WESTERN HARBOUR TUNNEL – COMMENTS AND OBJECTIONS

By Sid French BE PhD MIEAust NER

Figure 1 Sidescan plot left, and general plan right showing clash with Coal Loader Dolphin. Sources: Fig 126 and 119 of App K

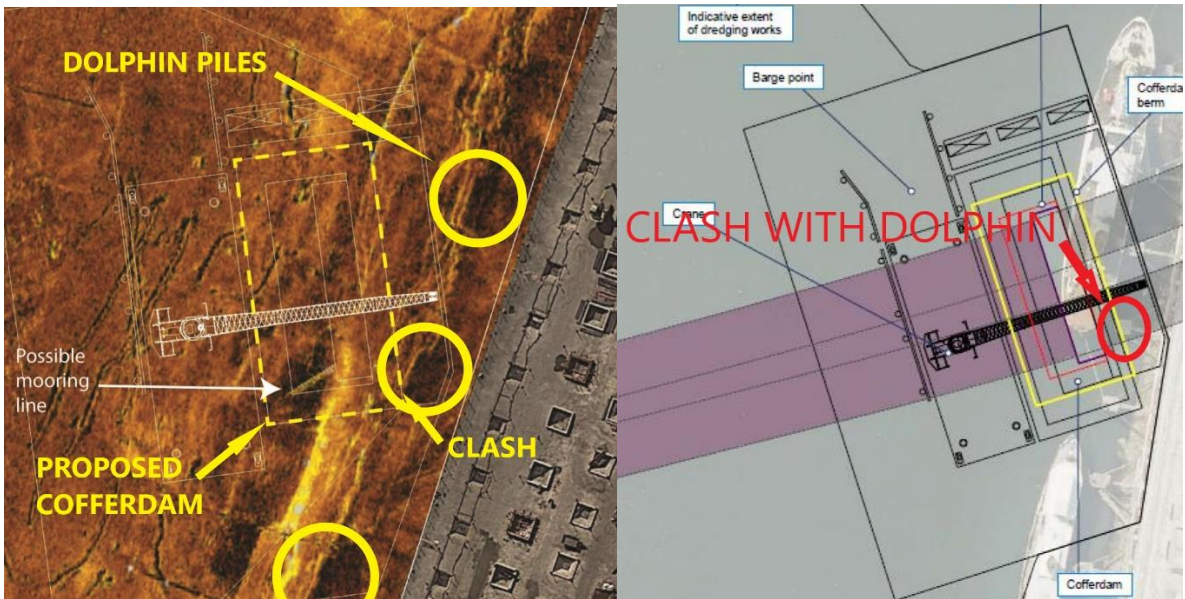
I **OBJECT** to the location of the cofferdam at the Coal Loader as I believe it will clash with the heritage structure of the Coal Loader in contravention of statements to the contrary. The following layouts appear to show that the interpretation of the sidescan sonar was deficient in that it did not

identify the berthing dolphins which occur along but which are offset from the face of the coal loader. These are part of the heritage fabric of the Coal Loader and must be avoided. **THE COFFERDAM MUST BE MOVED AT LEAST 2M** clear of the dolphins (SUCH CLEARANCE TO BE CONFIRMED BY EXPERT OPINION FOR THE AVOIDANCE OF DAMAGE TO THIS HERITAGE FABRIC).
